Access Compliance Report

Public Rights-of-Way

(Curb Ramps)

Intersection ID: N/A	Main Street: MILLENNIUM_AV	Cross Street: ANSLEY_GARDEN_DR	Location: NE
ADA ID: AED19973AEDF	Ramp Type: Perp	Initial Pass/Fail: Fail	Overall Compliance: No
Severity Score: 12.5			
Codes/Mitigation Info/Possible Solution		Field Measurements/Component Compliance

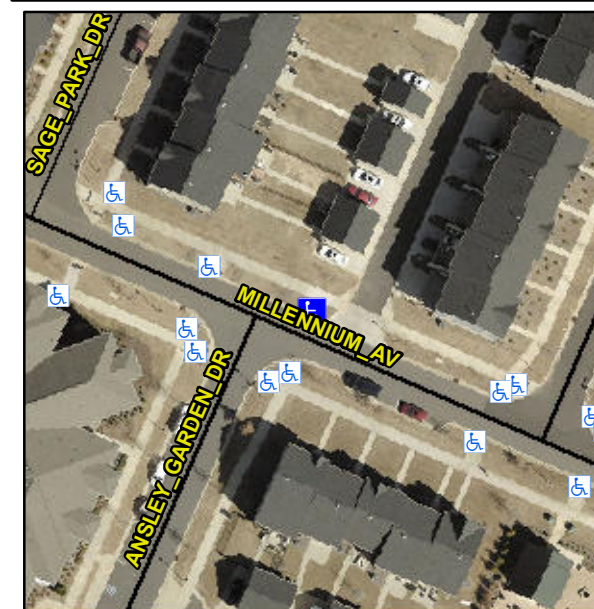
R304.2.2

Compliance	Description	Data	Compliance	Description	Data
N/A	Ramp Length (in)	88.0	No	Ramp Slope (%)	10.3
Yes	Ramp Width (in)	70.0	Yes	Ramp XSlope (%)	0.3
N/A	Flare Type LT	N/A	N/A	Flare Type RT	N/A
N/A	Flare Slope LT (%)	N/A	N/A	Flare Slope RT (%)	N/A
N/A	Flare Traversable LT?	N/A	N/A	Flare Traversable RT?	N/A
N/A	Landing Length (in)	N/A	N/A	DWS Provided?	N/A
N/A	Landing Width (in)	N/A	N/A	DWS Contrast?	N/A
N/A	Landing Slope (%)	N/A	N/A	DWS Length (in)	N/A
N/A	Landing X Slope (%)	N/A	N/A	DWS Full Width?	N/A
N/A	Landing Curb? (Y/N)	N/A	N/A	DWS Offset (in)	N/A
N/A	Shared Landing?	N/A			
N/A	Gutter Ponding?	N/A	N/A	Gutter Slope (%)	N/A
N/A	Gutter Lip Ht (in)	N/A	N/A	Gutter X Slope (%)	N/A
N/A	Painted X Walk1?	No	N/A	Painted X Walk2?	N/A
	X Walk 1 Direction	To SW		X Walk 2 Direction	N/A
N/A	X Walk 1 Width (in)	N/A	N/A	X Walk 2 Width (in)	N/A
	X Walk 1 Slope (%)	2.2		X Walk 2 Slope (%)	N/A
	X Walk 1 X Slope (%)	2.3		X Walk 2 X Slope (%)	N/A

Remove & Replace Entire Ramp.
